RE: Permit Application # PRMU20221555
Copperberry Condominiums ~ Fire Details Clarifications
City of Puyallup

Items listed below are in reference to the Copperberry Condominiums for clarification of the fire ratings and requirements and solutions to onsite deficiencies brought to our attention by the builder.

Cross Section B - PHS21.136 - Bill Riley - Copperberry Condominiums - South Building
Scale: 1/4 in = 1 ft

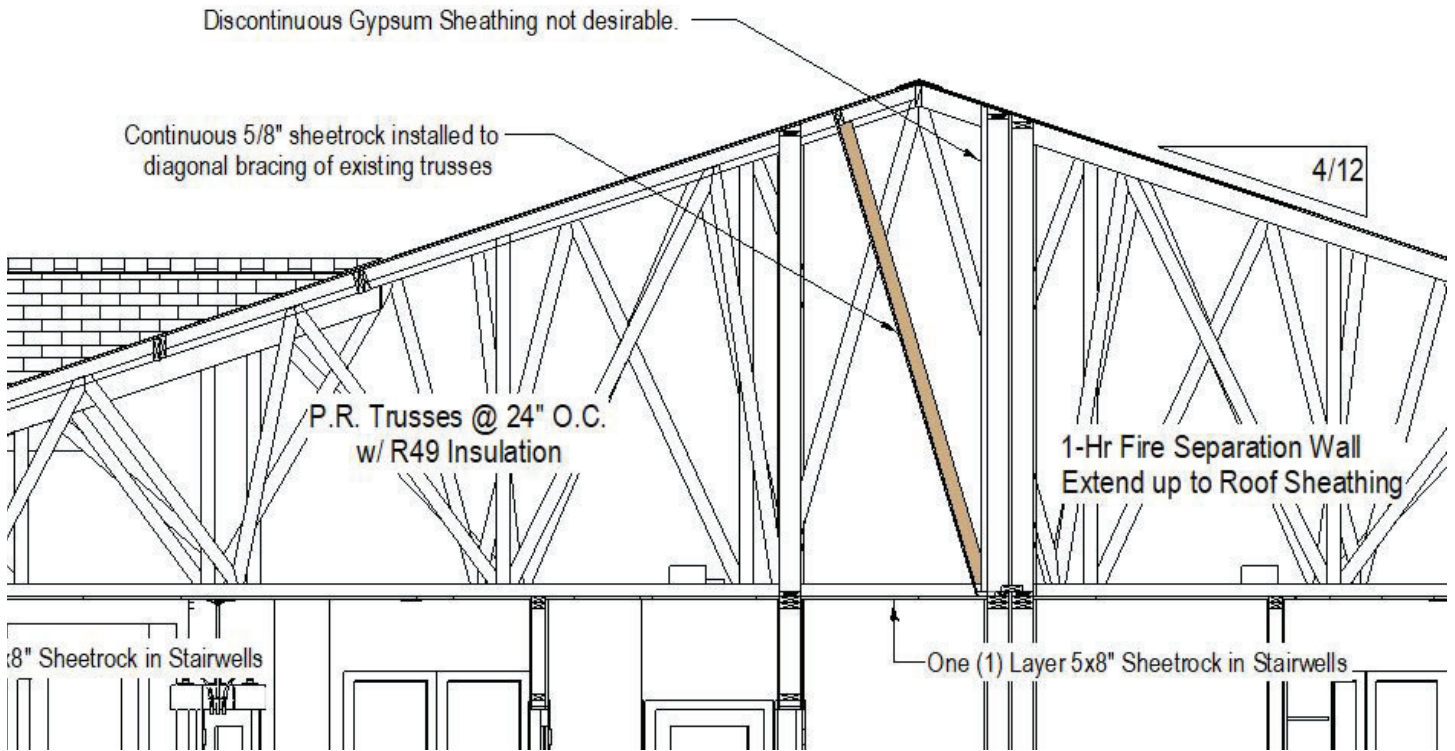
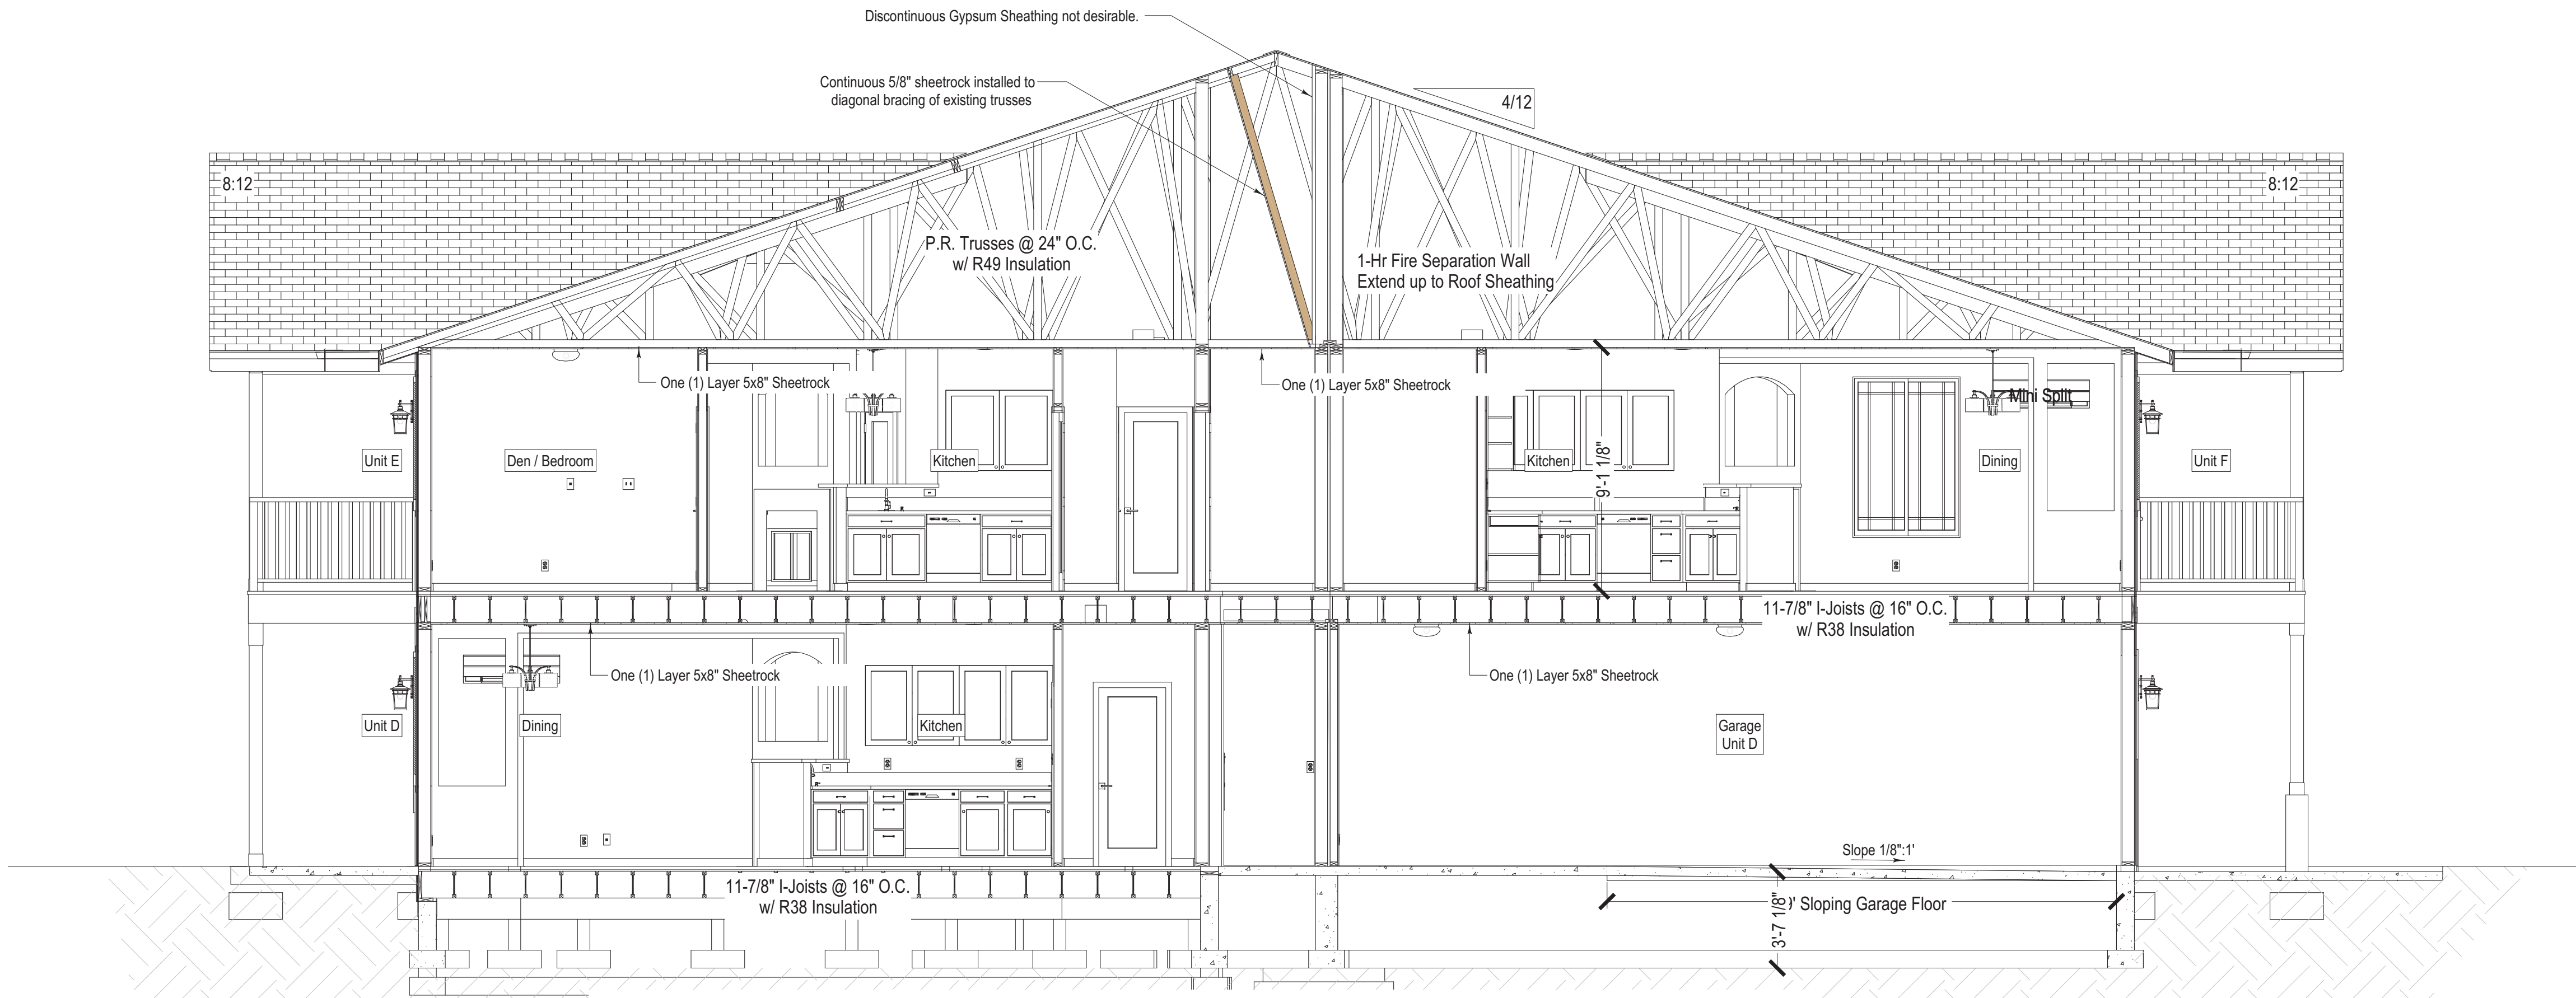
1. An area of the roof adjacent to the partywalls required the roof to be fire rated and sheetrock installed between the top chords of the trusses suspended by 2x2's. It has been brought to our attention the sheetrock does not extend fully between the truss chords on the sides and has shifted down from the ridge on both sides about two inches.

2. The hallway / stairwell is required to be fire rated and extend to the underside of the roof sheathing. The walls line up with the truss chords in most areas, however the truss uprights in the stairwell are not aligned with the partywall below and offset about an inch and a half (1-1/2"). This is not ideal as the sheetrock is discontinuous and is considered a weak link in the event of a fire emergency.

Solution please follow the attached detail to further fire rate and protect the framing elements in the case of a fire. The builder shall add additional 2x4's nailed between the truss chords as a nailer to attach new 5/8" sheetrock below with tight fitting seams, then wrap the top chord of the trusses. This will add an additional 40 minutes of burn rating to the unprotected 2x2's.

Solution; The builder shall block both top and bottom of the diagonal bracing and continuously sheet the diagonal bracing as shown in the attached plans view.
